### **REGULAR MEETING OF THIRD LAGUNA HILLS MUTUAL ARCHITECTURAL CONTROLS AND STANDARDS COMMITTEE\***

**Monday, November 28, 2022 – 9:30 a.m.  
Laguna Woods Village Board Room/Virtual Meeting  
24351 El Toro Road, Laguna Woods, California**

# Third ACSC – November 28, 2022

## Variance Requests

ATTACHMENT 4  
PROPOSED FLOOR PLAN

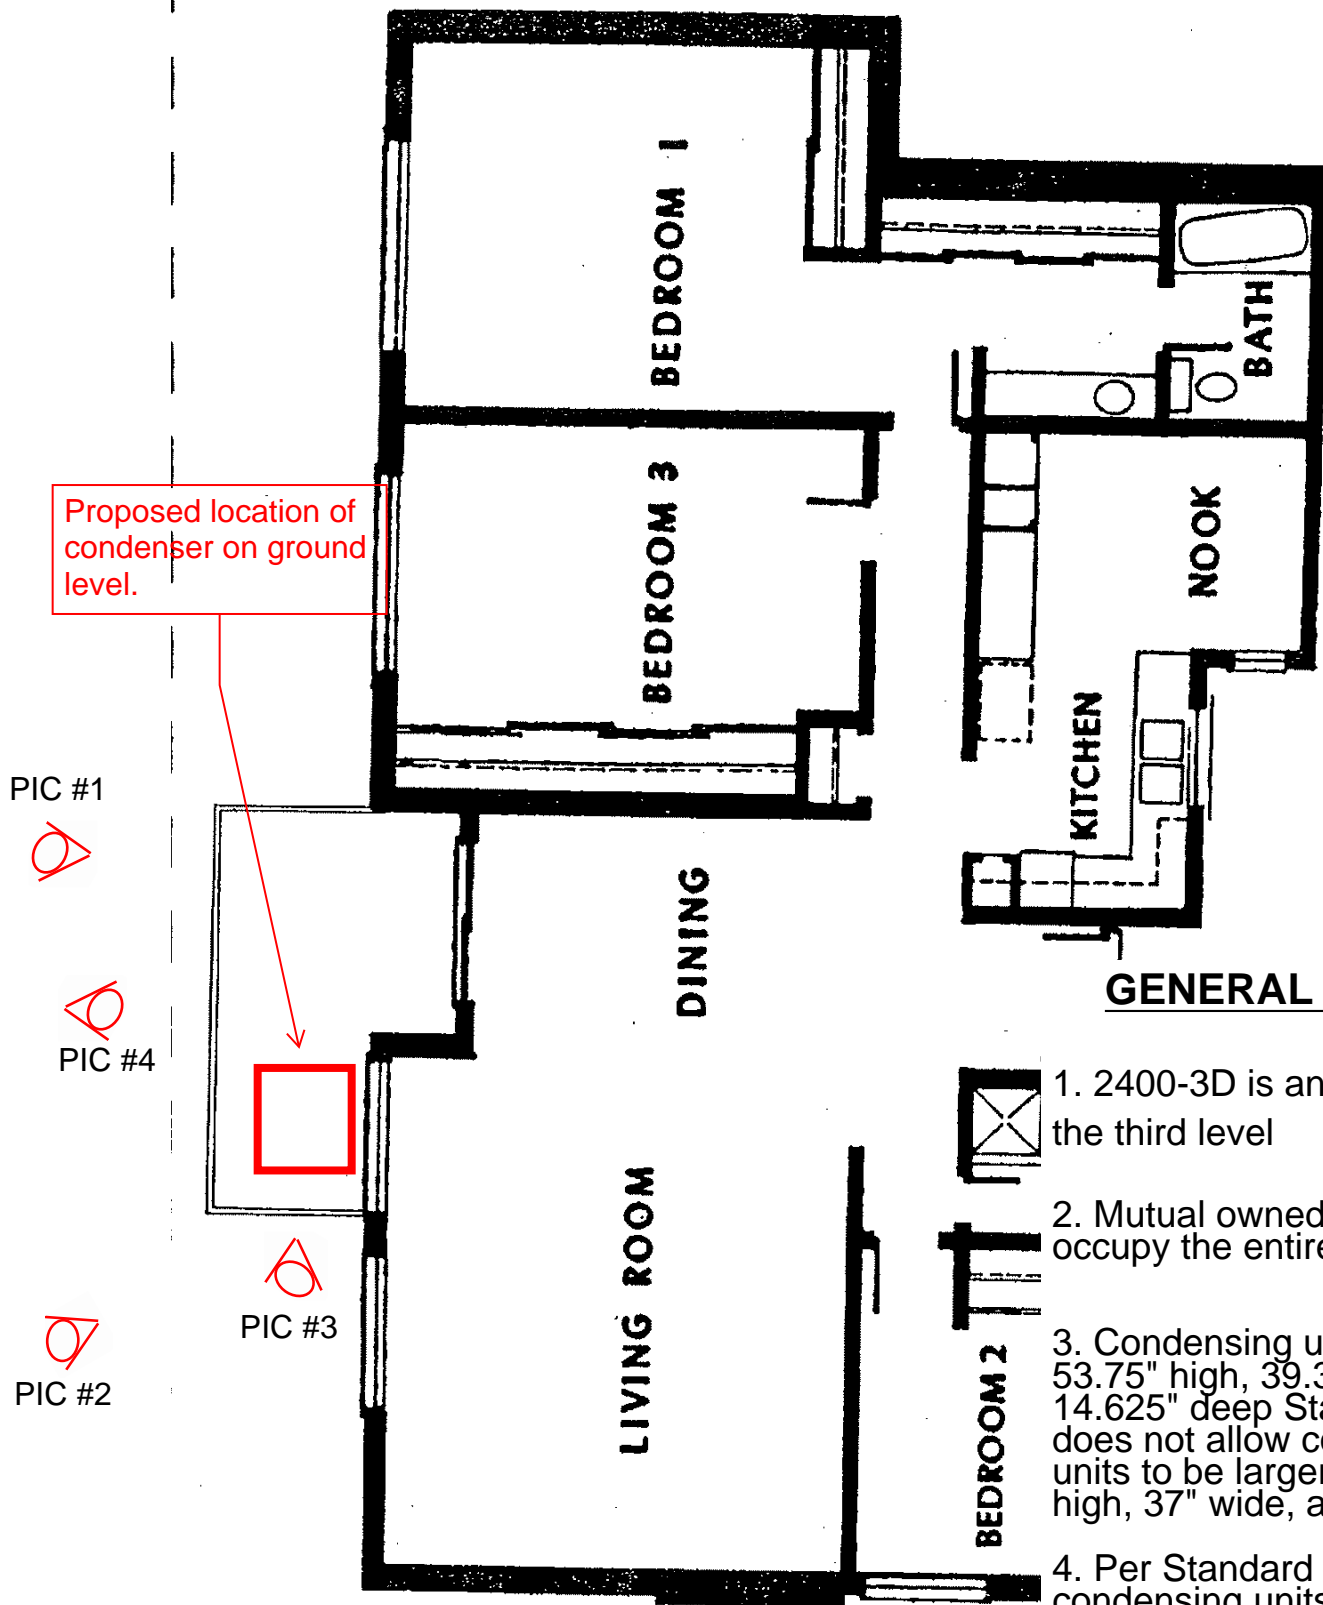
1. 2400-3D is an end unit on the third level
2. Mutual owned solar panel occupy the entire roof.
3. Condensing unit will be 53.75" high, 39.375" wide, 14.625" deep Standard 4.3.3 does not allow condensing units to be larger than 48" high, 37" wide, and 36" deep.
4. Per Standard 4.3.6 condensing units on third floors are to be installed directly above the manor
5. Proposed location has two existing condensers present.

- A.1. Installation must follow Standard 4: Air Conditioning Units/Heat Pumps.
- A.2. A City of Laguna Woods Building Permit will be required and provided to Manor Alterations to verify all code requirements have been satisfied.

- B.1. Condenser must be located within 24" of the building wall.
- B.2. All exterior wiring, condensate, and coolant lines must be encased in a single, square sheet metal two-piece chase way painted to match the color of the wall to which it is attached.
- B.3. The chaseway must be made rodent proof by installing wire mesh at the bottom of the chaseway.

ATTACHMENT 4  
SCOPE PLAN(S)  
PROPOSED

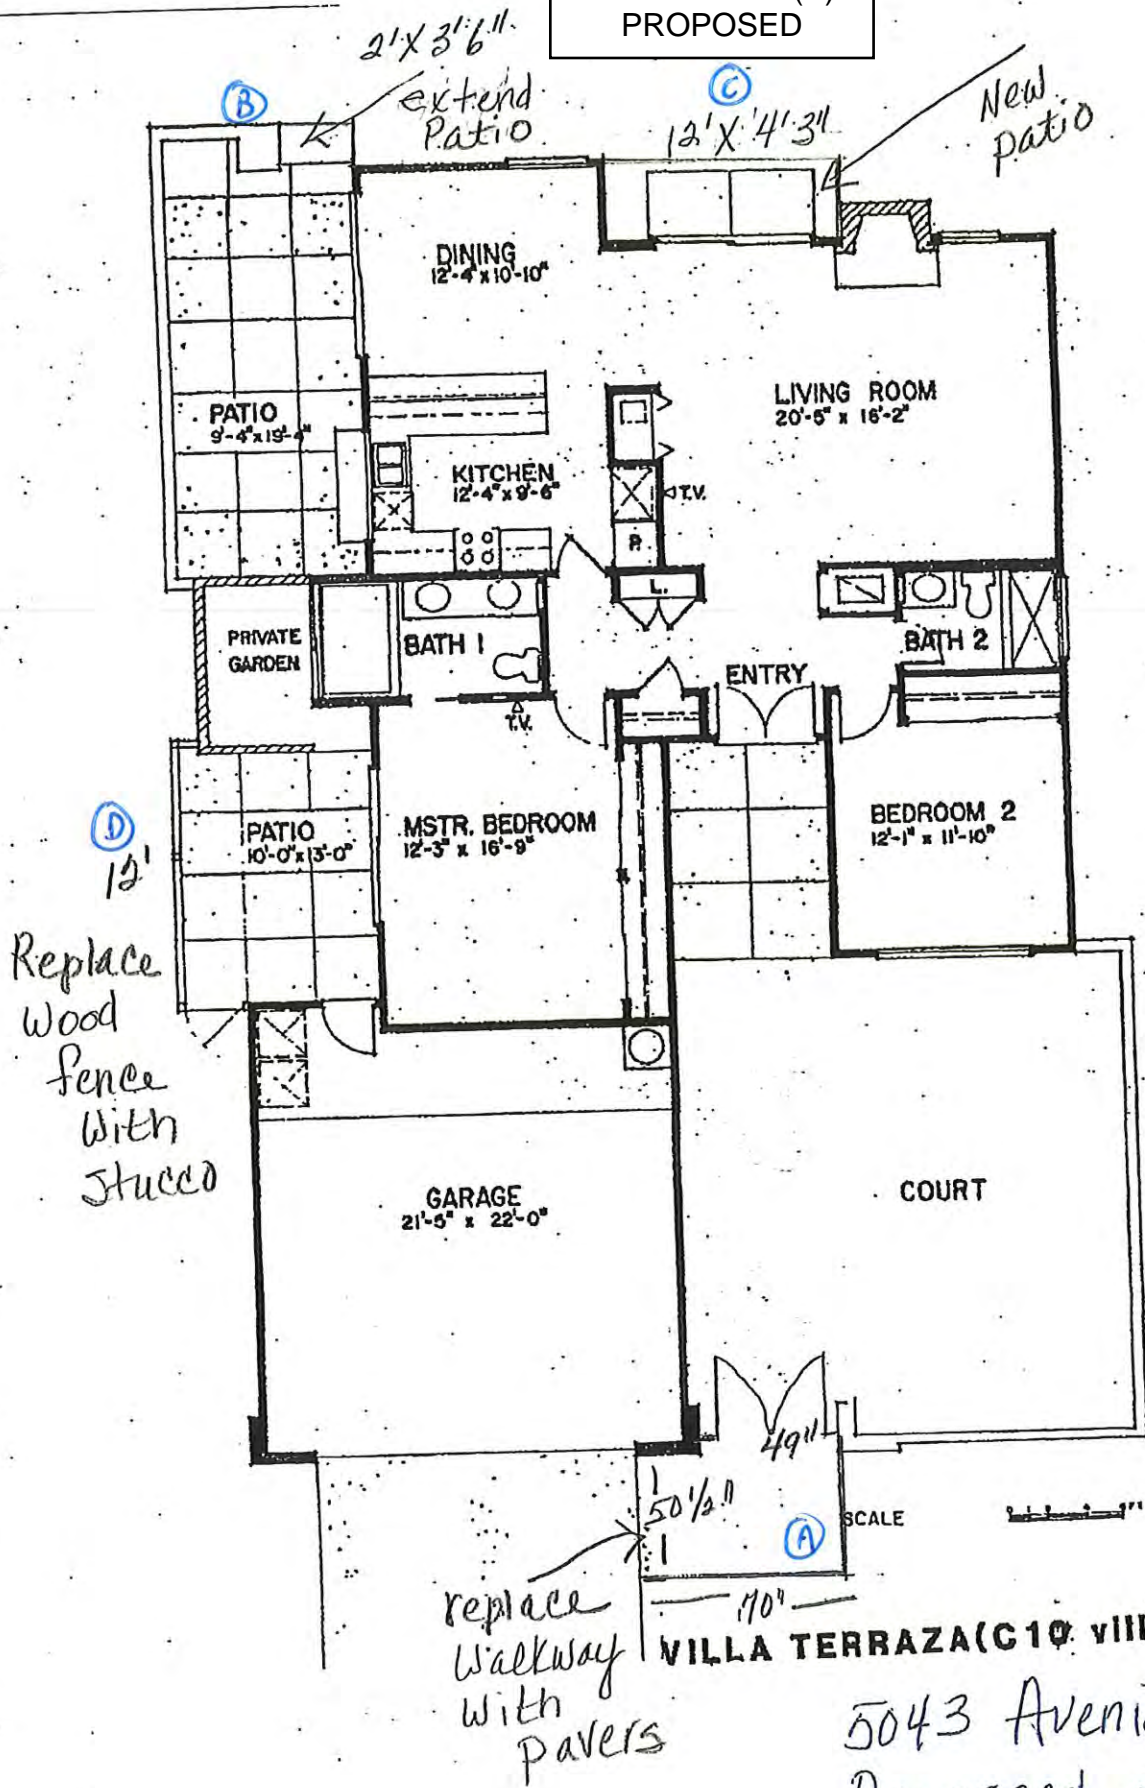
<b>C</b>	5043	1. Install pavers on walkway 2. Rear patio extension off of living room 3. Patio extension off the kitchen 4. Replace wood fence with a stucco wall	<ul style="list-style-type: none"> <li>5043 is a standalone manor. There are no manors behind 5043.</li> <li>Front walkway will be replaced with pavers</li> <li>Kitchen patio extension will be 2'x3'-6".</li> <li>Living room patio extension will be 12'x4'-3".</li> <li>Wood fence will be replaced by a stucco wall the dimensions are 12'x6'.</li> </ul> <p>Staff Recommendation: Approve</p>

- A.1. Due to this approval involving the use of Common Area, the member shall provide to Manor Alterations a copy of the Grant Deed and Legal Description for the unit, prior to application for Mutual Consent for Demolition and Alteration, for use in preparation of the "Recordable Common Area Agreement" as mentioned in Section G General Conditions.
- A.2. This approval does not change the number of bedrooms or the original maximum occupants permitted in the Unit.
- A.3. A City of Laguna Woods Building Permit will be required and provided to Manor Alterations to verify all code requirements for new or modified structural components, and shoring have been satisfied.

# ATTACHMENT 4 SCOPE PLAN(S) PROPOSED

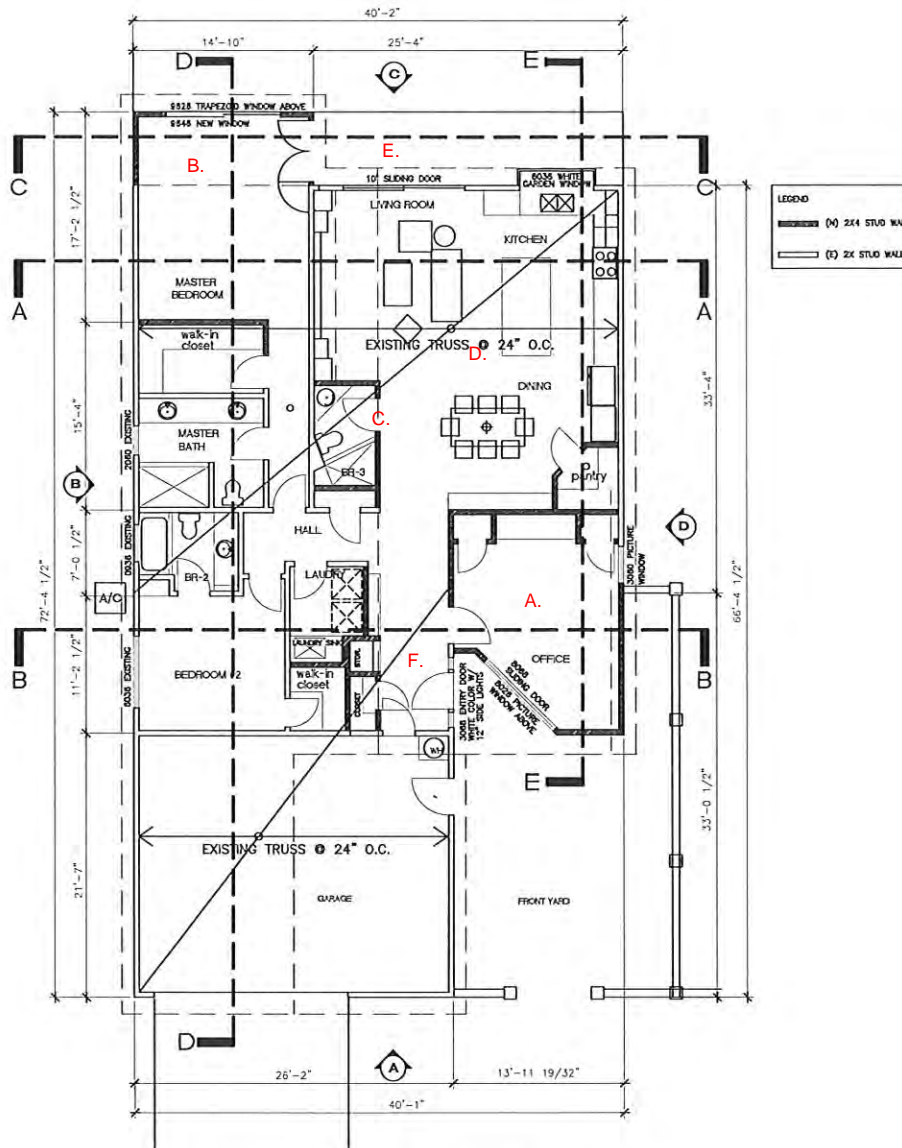
- A. ROOM ADDITION AT FRONT PATIO (OFFICE); 130 SQFT; 14' X 11'
- B. ROOM EXTENSION OF MASTER SUITE AT REAR PATIO; 90 SQFT; 6' X 14'-10"
- C. INSTALLATION OF NEW 3RD BATHROOM AND LAUNDRY BY THE HALLWAY
- D. RELOCATION OF KITCHEN TO THE ORIGINAL DINING AREA; SWAPPING KITCHEN/DINING
- INSTALLATION OF NEW KITCHEN GARDEN WINDOW; 6'-0" X 6'-6" *To be processed through a Mutual Consent*
- E. ENLARGE AND RELOCATE THE LIVING ROOM SLIDING DOOR; 10' LONG; 10'-0" X 6'-8"
- F. RELOCATION OF NEW 36' ENTRY DOOR WITH SIDE LIGHTS; 5'-4" X 6'-8"

- A.1. Due to this approval involving the use of Common Area, the member shall provide to Manor Alterations a copy of the Grant Deed and Legal Description for the unit, prior to application for Mutual Consent for Demolition and Alteration, for use in preparation of the "Recordable Common Area Agreement" as mentioned in Section G General Conditions.
- A.2. This approval changes the number of bedrooms from three bedroom to two bedrooms and an office.
- A.3. The Member shall provide plans, specifications, and calculations from a duly licensed architect or structural engineer to conform to the Building Code for all foundation, framing, and beam additions for the work of this variance.
- A.4. A City of Laguna Woods Building Permit will be required and provided to Manor Alterations to verify all code requirements for new or modified structural components, and shoring have been satisfied.

- B.1. Prior to the Issuance of a Mutual Consent for Alterations, a complete set of unit specific plans, specifications and calculations prepared by a licensed architect or structural engineer depicting the proposed improvement must be

submitted to the Division office located in the Laguna Woods Village Community Center. The plans must depict any required structural modifications ensuring the structural integrity of the building is maintained upon completion of the proposed improvement.
